RIALTO VILLAGE
MASTER DEVELOPMENT PLAN/PLANNED UNIT DEVELOPMENT
MDP # 026-06 PUD # 06-019

Re: **Rialto Village**

MDP # 026-06

The City Staff Development Review Committee has reviewed Rialto Village Master Development Plan **MDP # 026-06**. Please find enclosed a signed copy for your files. Your plan was approved for acceptance, however please note the following:

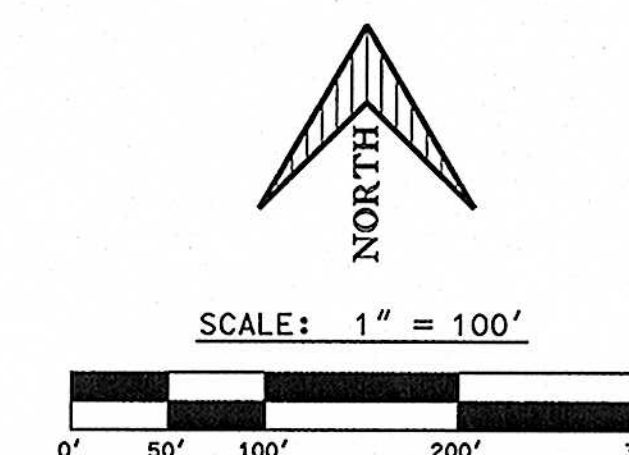
In consideration of public safety and convenience, excessive grades by reason of topography should be avoided in street layouts and arrangements. Any access and R.O.W. issues along state facilities will need to be resolved with the **Texas Department of Transportation (TXDOT)**. For information about these requirements you can contact TXDOT at 615-5814.

SAWS Aquifer Protection and Evaluation will require the following pursuant to the Aquifer Protection Ordinance No. 81491:

- 100 year Flood Plain shown and buffering (If applicable)
- Significant recharge features and buffering (If applicable)
- Category letter for all site specific plats (If Category 2 or 3, an Aquifer Protection Plan is required (If applicable))
- Additionally, a Water Pollution Abatement Plan or Contributing Zone Plan must be submitted to and approved by the Texas Commission on Environmental Quality (TCEQ) prior to construction.

- 2006 Tree Preservation ordinance standards per UDC Section 35-523 – a Tree Preservation Plan is required prior to any work on site. This can be submitted either as a site work permit or at the platting stage. Additional permitting fees and affidavits will be needed to obtain tree permits during the platting and/or building permit stages. This project appears to be suited to a Tree Stand Delineation (30% preservation of tree canopy at MDP or 35% preservation at platting) based on the large lot sizes and tree canopy area. Note that flood plain area must be delineated separately (preserved at 80% for significant trees and 100% for heritage trees).

- Landscape ordinance per UDC Section 35-511. It appears all landscape points can be met by preserving existing vegetation as well as meeting any mitigation requirements (either through preservation of smaller material or transplanting). Recommend securing knowledgeable Landscape Architect at planning and design phase to better utilize existing trees and vegetation. Preservation will eliminate the need for irrigation. Staff would be willing to meet with developer at design stage to assist with tree preservation and landscape plan.

- The parkland provided shall be shown as “Park” or “Open Space” on a plat; UDC sections 35-503(e) *Designation of Parkland*.
- The parkland provided is dedicated to the Home Owners Association.
- The instruments creating the Home Owners Association are provided by the second application for plat approval; UDC sections 35-503(e) *Designation of Parkland*.

- Parkland dedication must be platted by the second phase of residential development; UDC section 35-503(f) *Development Phasing*.
